Access Compliance Report

Public Rights-of-Way

(Curb Ramps)

Intersection ID: 14410	Main Street: DUNAVANT_ST	Cross Street: S_TRYON_ST	Location: NE
ADA ID: AFF22F0483D4	Ramp Type: PerpDiag	Initial Pass/Fail: Fail	Overall Compliance: No
Severity Score: 12.5			
Codes/Mitigation Info/Possible Solution		Field Measurements/Component Compliance

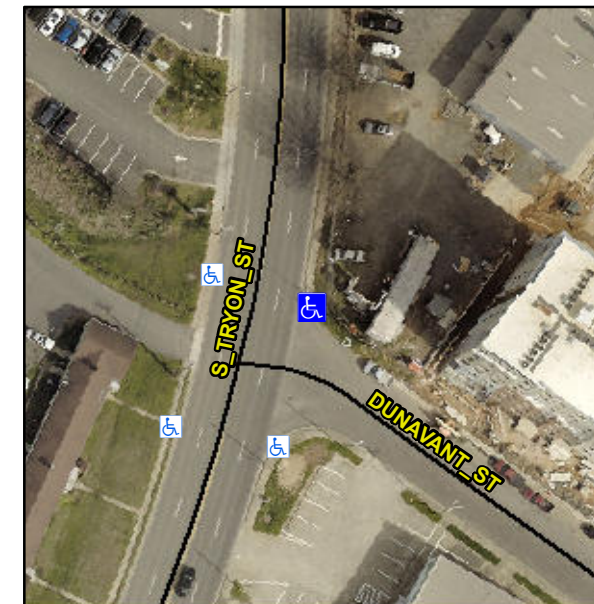
PROW/ADA:

Not Found, R304.2.2

Compliance	Description	Data	Compliance	Description	Data
N/A	Ramp Length (in)	60.0	No	Ramp Slope (%)	10.1
Yes	Ramp Width (in)	48.0	Yes	Ramp XSlope (%)	1.3
N/A	Flare Type LT	N/A	N/A	Flare Type RT	N/A
N/A	Flare Slope LT (%)	N/A	N/A	Flare Slope RT (%)	N/A
N/A	Flare Traversable LT?	N/A	N/A	Flare Traversable RT?	N/A
N/A	Landing Length (in)	N/A	N/A	DWS Provided?	N/A
N/A	Landing Width (in)	N/A	N/A	DWS Contrast?	N/A
N/A	Landing Slope (%)	N/A	N/A	DWS Length (in)	N/A
N/A	Landing X Slope (%)	N/A	N/A	DWS Full Width?	N/A
N/A	Landing Curb? (Y/N)	N/A	N/A	DWS Offset (in)	N/A
N/A	Shared Landing?	N/A			
N/A	Gutter Ponding?	N/A	N/A	Gutter Slope (%)	N/A
N/A	Gutter Lip Ht (in)	N/A	N/A	Gutter X Slope (%)	N/A
N/A	Painted X Walk1?	No	N/A	Painted X Walk2?	No
	X Walk 1 Direction	To W		X Walk 2 Direction	To S
N/A	X Walk 1 Width (in)	N/A	N/A	X Walk 2 Width (in)	N/A
	X Walk 1 Slope (%)	0.4		X Walk 2 Slope (%)	0.1
	X Walk 1 X Slope (%)	0.7		X Walk 2 X Slope (%)	0.6

Possible Solutions:

Remove & Replace Curb Ramp With Two New Directional Ramps or Equivalent.
